FINAL ENVIRONMENTAL IMPACT REPORT

Rio Bravo Ranch Specific Plan

Portion of Section 4, T29S, R29E  
Kern River County Park Area

Date: September 26, 1975

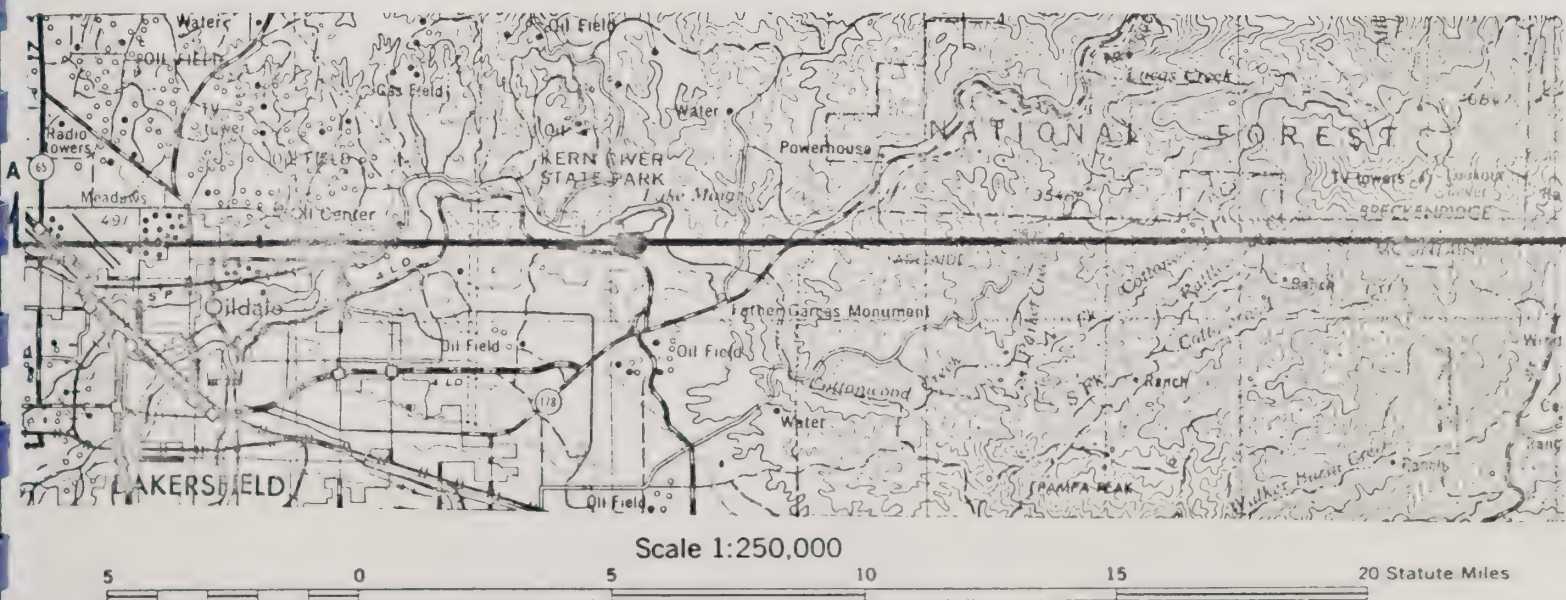
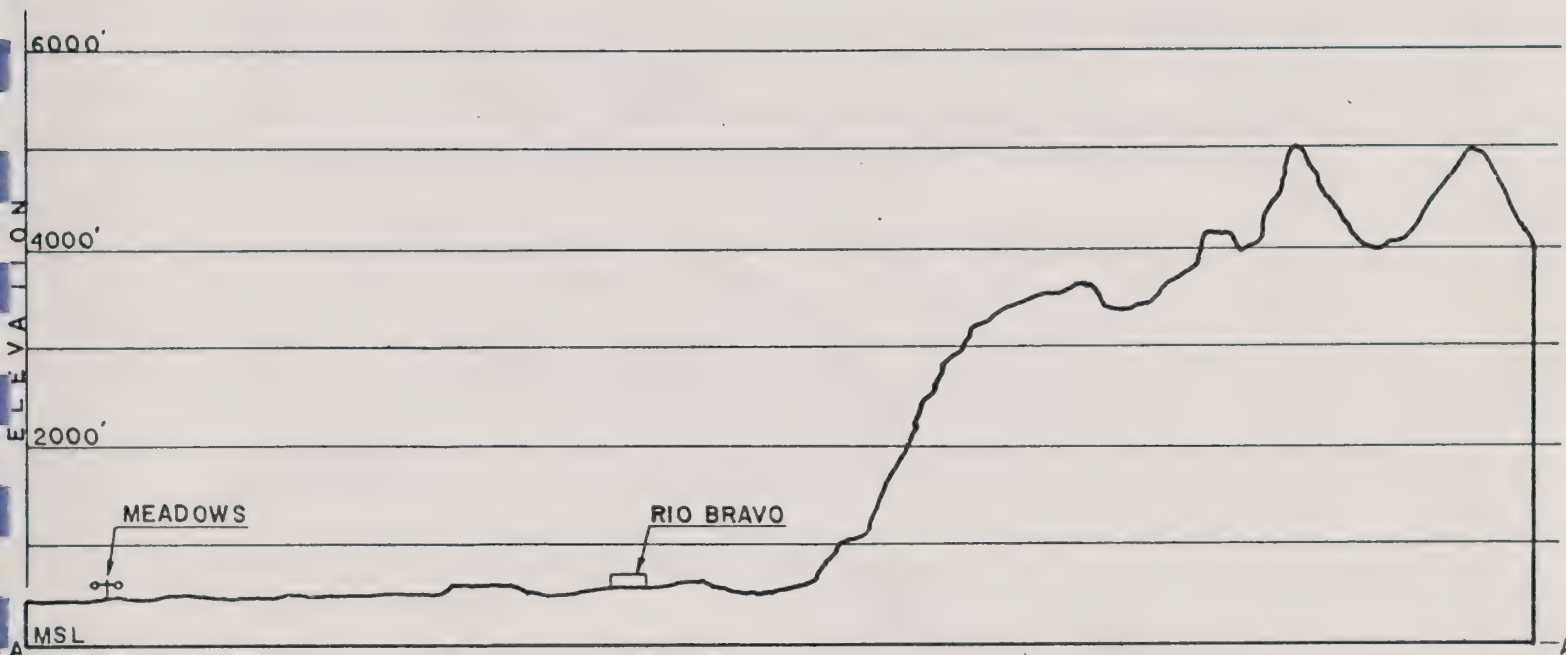
Response: It is not implied that all runoff will go into Lake Ming. The 21% volume of Lake Ming was given for the Layman to compare 17.8 acre-feet

with. Applicant's representative uses .38 runoff factor for proposed project. Also, 1.71" (4.34 C.M.) 50-year, 24-hour storm is used. Staff uses a record 24-hour precipitation of 3.02 cm which is considerably less for proposed project site. Either way of predicting maximum runoff may be correct. On the other hand, both methods may be wrong.
